Corrections and Additions for the 1st Impression

Author/Title: Forrest: Organic Electronics

ISBN: 9780198529729

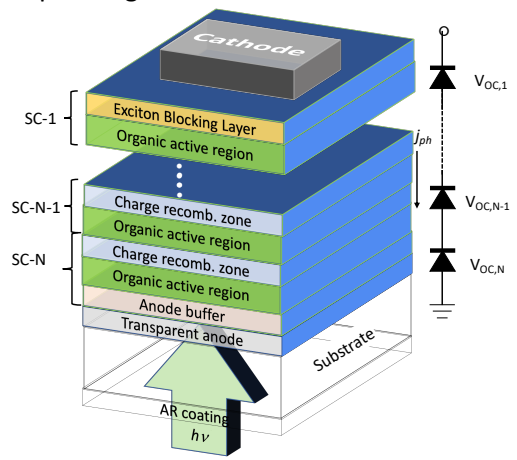
Page number	Line number	Incorrect content	Correction/instructions on how to correct
1	22	Column 2, para. 3, line 17	<i>tridentate</i> molecule (have 3 ligands, or “teeth”)	<i>bidentate</i> molecule (have 2 bonds, or “teeth” to each ligand)
2	33	Table 2.1	<div style="display: flex; align-items: center;"> <div style="background-color: #d9e1f2; padding: 5px; margin-right: 10px;">Monoclinic</div>  </div>	Change labels above both rectangles to “ $\alpha, \gamma = 90^\circ$ ”
3	35	Column 2, 1 st paragraph, last line	“ $\mathbf{a} \cdot (\mathbf{b} \times \mathbf{c})$ ”	“ $\bar{\mathbf{a}} \cdot (\bar{\mathbf{b}} \times \bar{\mathbf{c}})$ ”
4	42	Fig. 2.9, vertical axis label	“Energy/ hcR ”	“Energy/ hcR_∞ ”
5	43	Column 2, 2 nd line from bottom.	“ $-\Delta\Phi(\mathbf{r})$ ”	“ $-\nabla\Phi(\mathbf{r})$ ”
6	45	Column 1, 1 st full para., line 7	“a full electron charge”	“ $0.1q$ ”
7	76	Figure 3.1 B	Diagram at far right shows “S=0”	Change to “S=1”

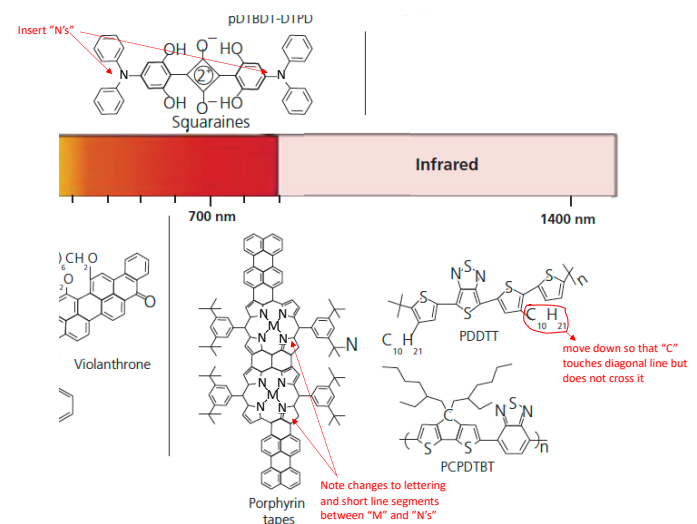
29	375	Col. 2, 2 nd line from bottom	“LUMO of the HBL is too low to block electrons”	“LUMO energy of the HBL is too small”
30	376	Col. 1, line 1	“HTL”	“HBL”
31	377	Figure. 6.8	x-axis labels missing	Please fix as shown
